Document title: Response to 2nd Notice of Deficiency, CAMU Post-Closure Care
Plan Report, August 2004

RESPONSE TO COMMENTS NEW MEXICO ENVIRONMENT DEPARTMENT (NMED) SECOND NOTICE OF DEFICIENCY JULY 12, 2004

Comments by the Permits Management Program, Hazardous Waste Bureau, NMED
for
U.S. Department of Energy (DOE) / Sandia National Laboratories (SNL)
Response to December 17, 2003 NMED Notice of Deficiency for
Post-Closure Care Plan (PCCP) for the Corrective Action Management Unit (CAMU)
Technical Area 3
March 2004

Figure 2-3
Areal Configuration of the Corrective Action Management Unit (CAMU)
Showing Area Subject to Post-Closure Care

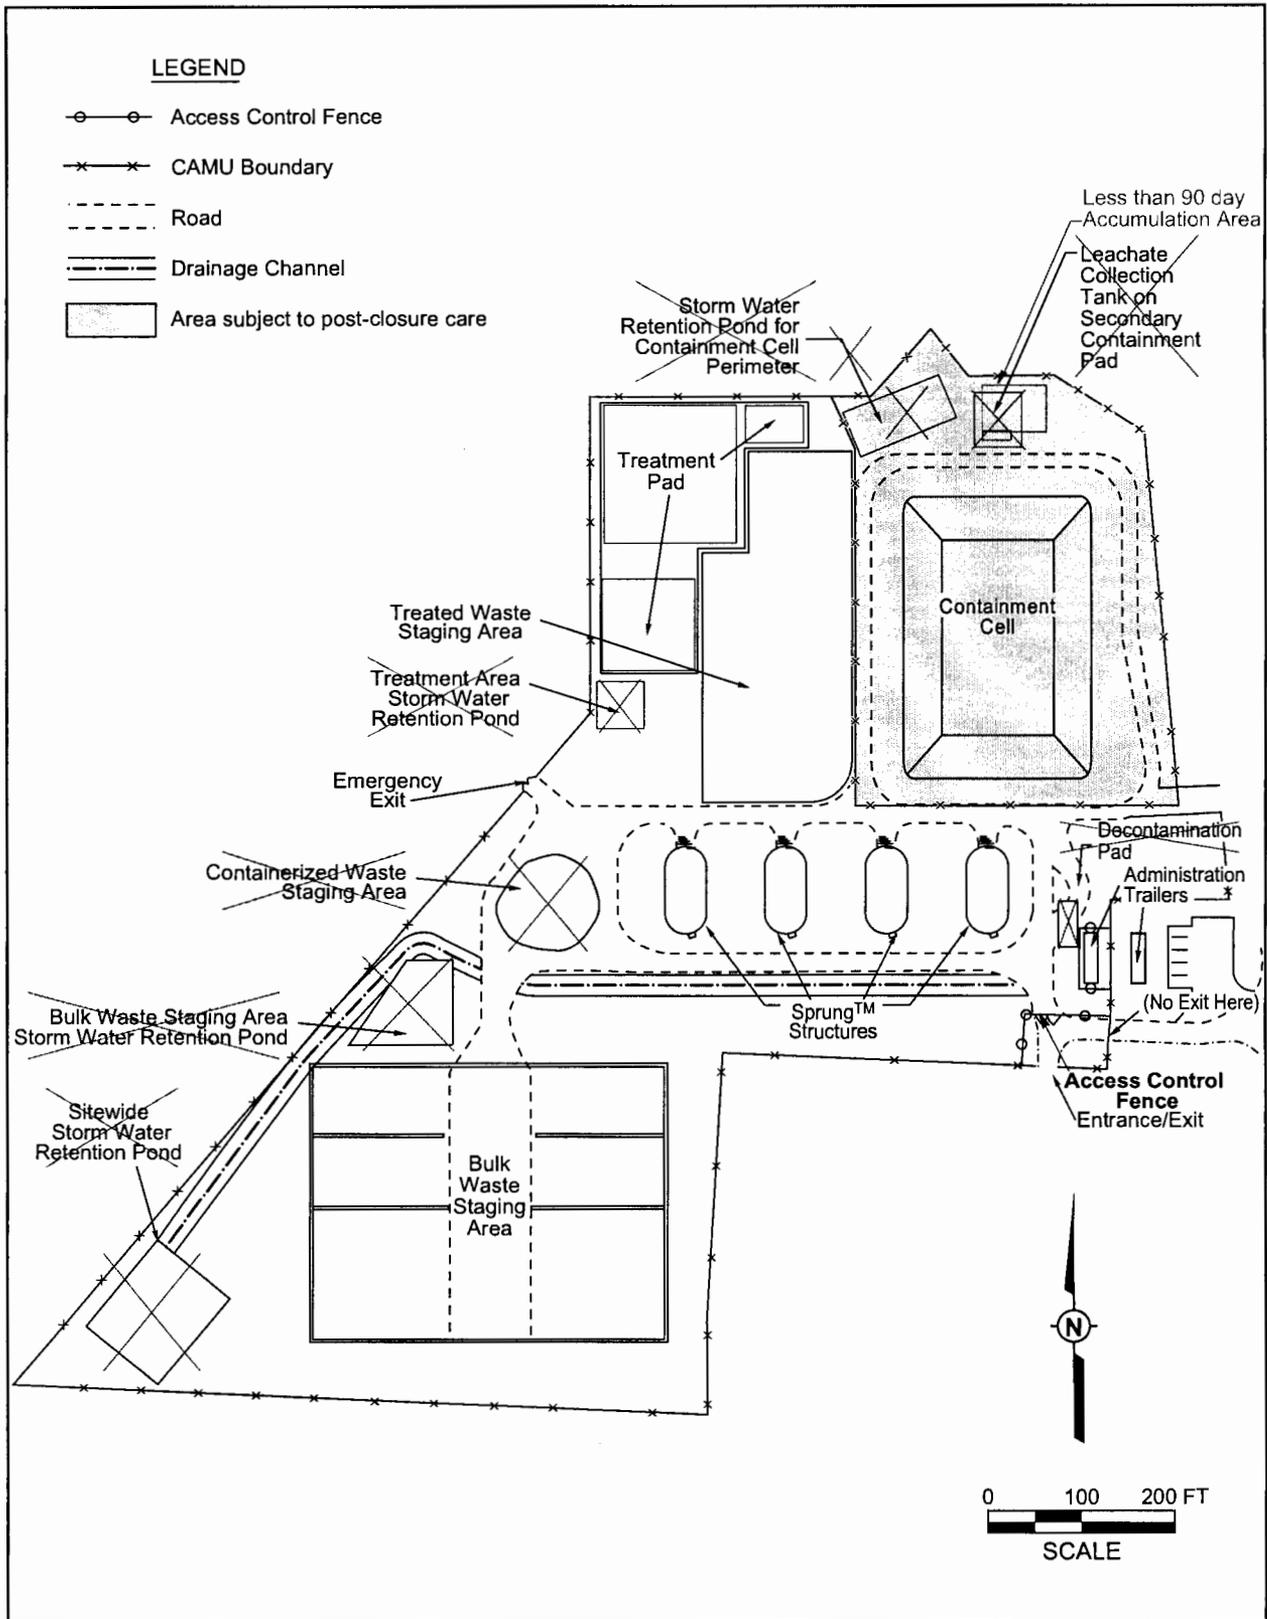
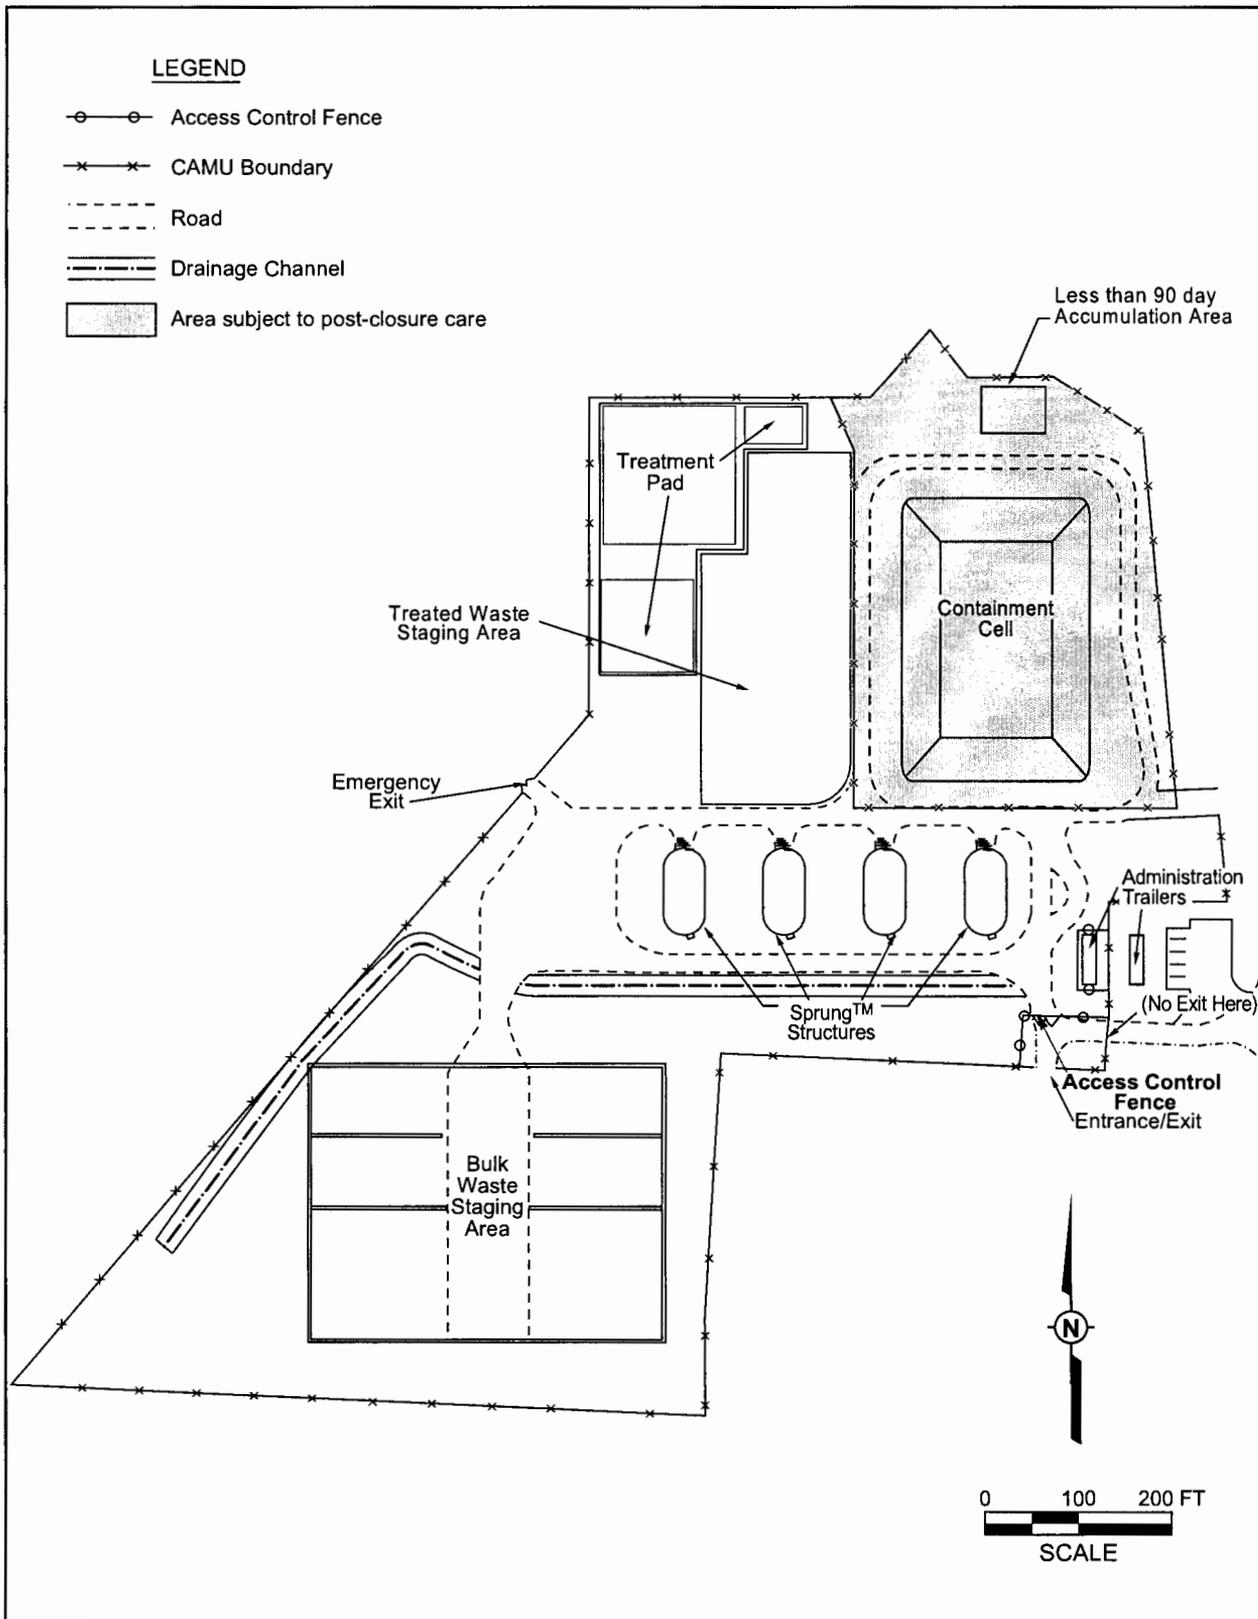
6. Revised PCCP, Figure 2-3 – A leachate collection tank on a secondary containment pad is shown within the area subject to post-closure care. This tank has already been decommissioned and 55-gallon drums for leachate storage are being used at the less-than-90-day area. As this pad is intended to serve as the less-than-90-day area, this figure should be labeled as such and reference to the leachate collection tank deleted.

Response: Figure 2-3 has been revised to delete the leachate collection tank and pad, and to include the less-than-90-day area. The less-than-90-day area is used to stage drums on secondary containment pallets on a gravel base course, approximately 3 inches deep. In addition, we noted that Figure 2-3 still included the storm water retention ponds, the containerized waste staging area, and the decontamination pad; because these areas were removed during CAMU closure, we have deleted them from Figure 2-3.
